CROSSLEY HILL ESTATES SUBDIVISION

APPLICATION NUMBER 12 DATE June 5, 2014

REQUEST Subdivision

DETAIL SITE PLAN

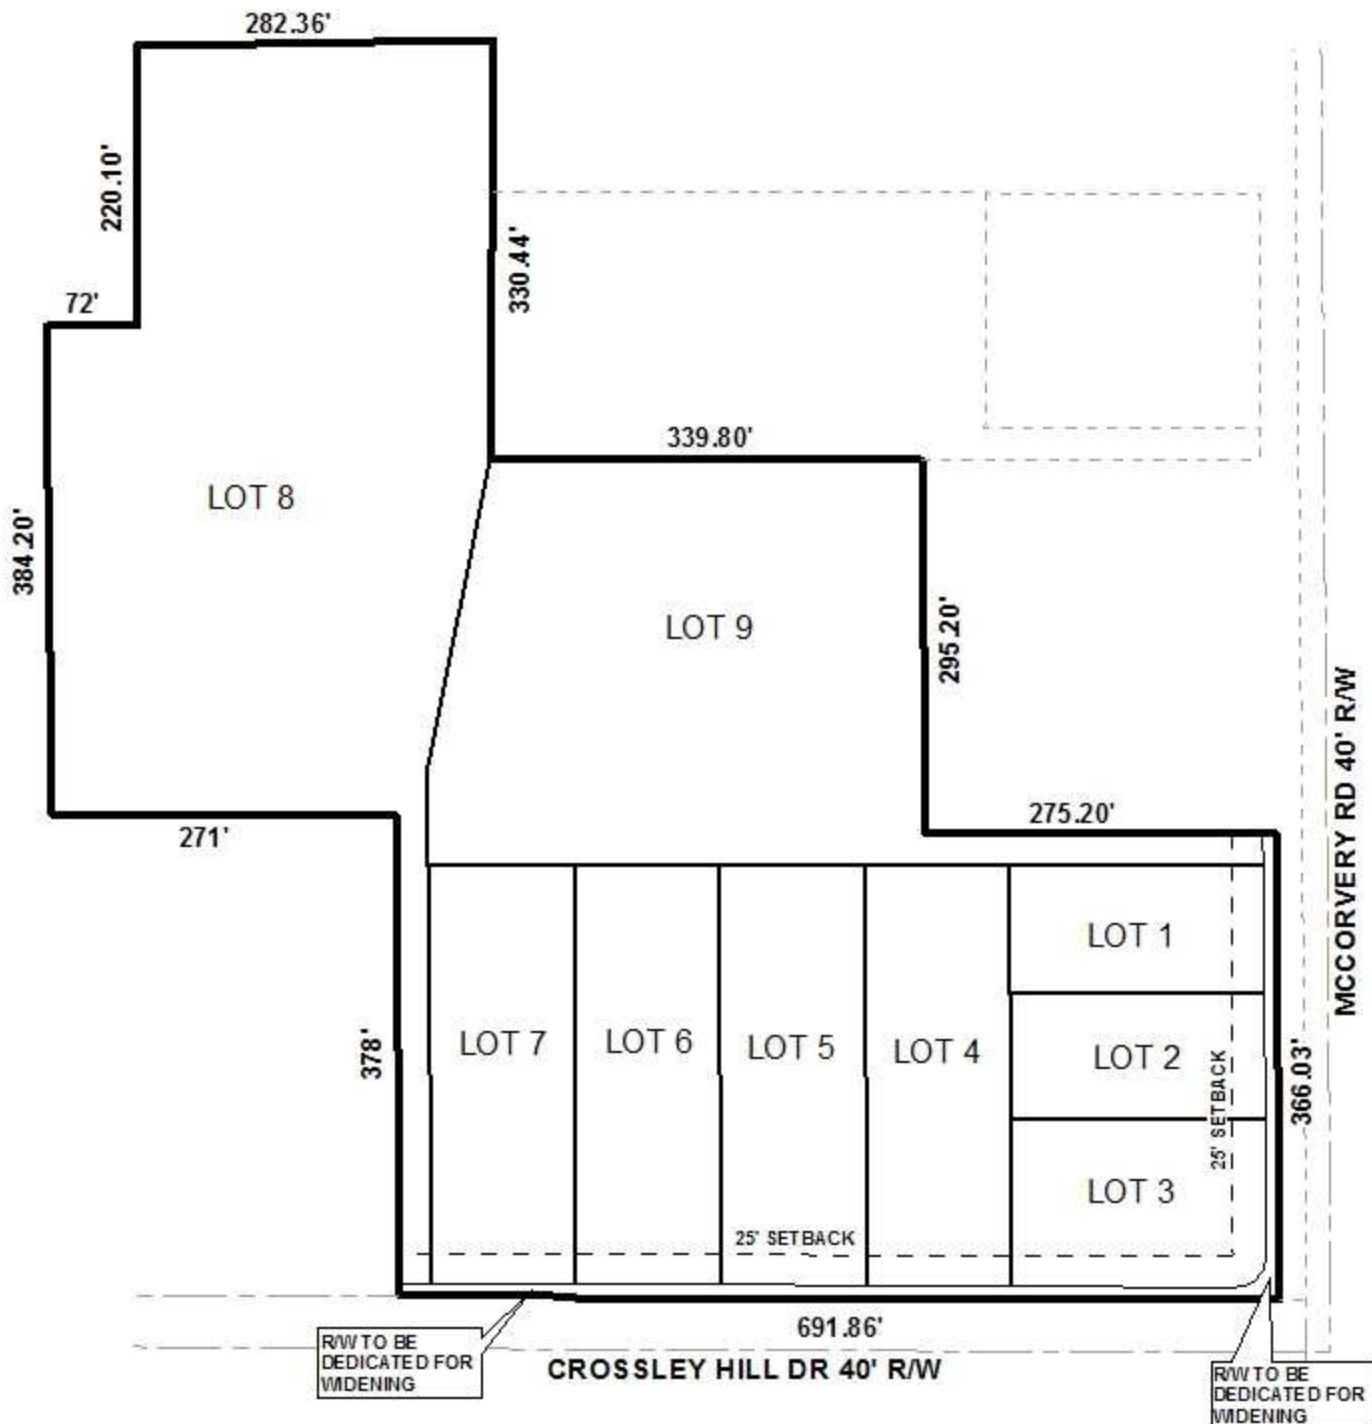
The applicant proposes that Lots 8 and 9 be “flag” lots, with Lot 8 proposed to have a 25’ wide by 378’ ± long pole with access to Crossley Hill Drive and Lot 9 proposed to have a 25’ wide by 275’ long pole with access to McCovery Road. There are currently 3 other “flag” lots in the area, two of which were approved by the Planning Commission at its April 7, 2011 meeting. Because of the previous approvals in the area, a waiver of V.D.1 may be appropriate; however, it should be pointed out the previous approvals were located on paved roads. If approved, resubdivision of Lots 8 and 9 and, in fact, all lots should not be allowed until such time that additional frontage on a paved public street or compliant public/ private street is provided.

The proposed site has road frontage on both Crossley Hill Drive and McCovery Road, two unpaved minor streets with an existing 40 foot right-of-way. A 60 foot right-of-way is required and it appears that additional dedication of 10’ is proposed. It should be noted that because Crossley Hill Drive and McCovery Road are both unpaved roads, staff would typically recommend denial of the proposed 9 lot subdivision. However, if approved, sufficient right-of-way to provide 30 feet from centerline from Crossley Hill Drive and McCovery Road should be depicted on the Final Plat.

The 25-foot minimum building setback is shown and labeled on the preliminary plat; however, it is improperly located for Lots 8 and 9. The setback line for Lots 8 and 9 should be revised to

depict the 25' minimum building setback line from where the poles meet the "flag", or where the lots meet the minimum building width of 60 feet. If approved, the corrected minimum building setback line should be illustrated on the Final Plat.

As a means of access management, a note should be placed on the Final Plat limiting lots 4-8 to one curb-cut to Crossley Hill Drive and Lots 1, 2,3 and 9 one curb-cut to McCorvery Road with the size, design, and location of all curb-cuts to be approved by Mobile County Engineering and conform to AASHTO standards.

The plat does not depict each proposed lot in square feet and acres; if approved, revisions should be made on the Final Plat to depict all lots in both square feet and acres or a table should be furnished providing the same information.

The site has property lines at an intersection corner. Section V.D.6. of the Subdivision Regulations requires that *"property lines at street intersection corners shall be arcs having radii of at least 10 feet or shall be chords of such arcs."* The curb radii is depicted on the preliminary plat, and if approved should be depicted on the Final Plat as well.

Also, it appears that a portion of the proposed Lot 8 contain wetlands and is within the Miller Creek Watershed. The potential presence of wetlands indicate that the area may be environmentally sensitive; therefore, the approval of all applicable federal, state and local agencies would be required prior to the issuance of any permits or land disturbance activities.
